SERVICE BULLETIN		
To: For the attention of: Please copy to:	All Dealers Service Manager/After Sales Manager The Dealer Principal The Warranty Supervisor Aston Martin Technician(s) The Parts Manager	Reference SB0283 Issued: 03rd February 2009 Page 1 of 10
Model:	V8 Vantage, Coupe and Roadster DB9, Coupe and Volante DBS	
VIN Range:	All	
Subject:	Satellite Navigation Display Screen, Repair to the Transport Mechanism

Reason for this Service Bulletin

Figure 1

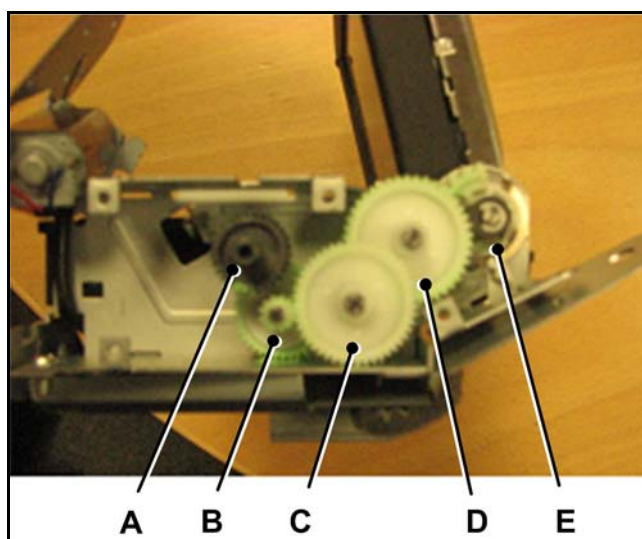
There have been some occurrences where the Satellite Navigation (Sat Nav) display screen will not move. The cause has been identified as Gear E in the transport mechanism (see Figure 1). The manufacturer of the system has released a repair kit to install a new Gear D and a new Gear E. Follow the Workshop Procedure to do the repair.

Figure 12

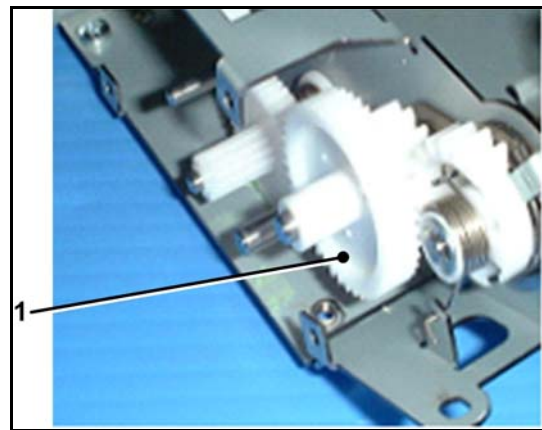
14. Pull Gear D off of its spindle to remove it (see Figure 12). Discard Gear D.

Figure 16

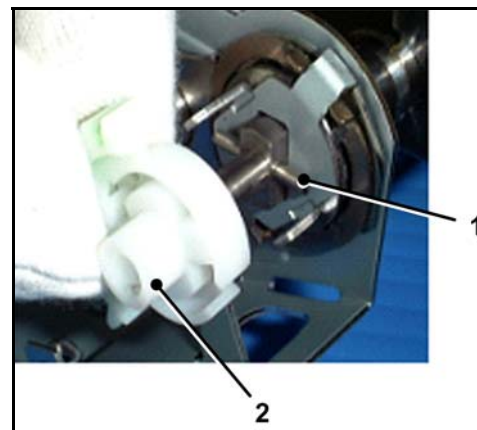
19. Pull Gear E (2) off of its spindle. Do not move or lose the drive pin (1) (see Figure 16). Discard Gear E.

Figure 18

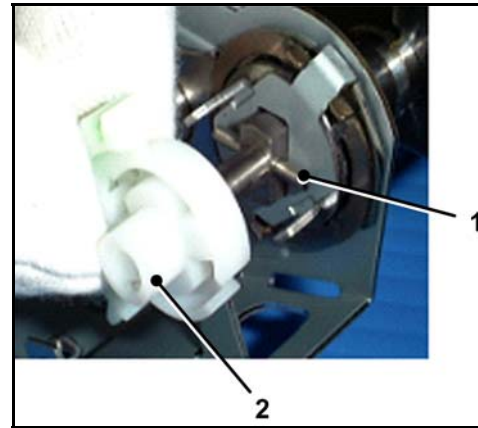
22. Put the new Gear E on to the spindle. Make sure that the drive pin (1) is correctly aligned.

Figure 21

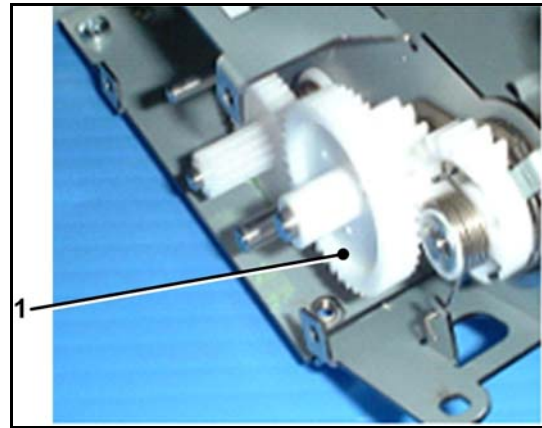
28. Install the new Gear D on to its spindle (see Figure 21). Make sure that the teeth on the small gear wheel engage correctly with Gear E.
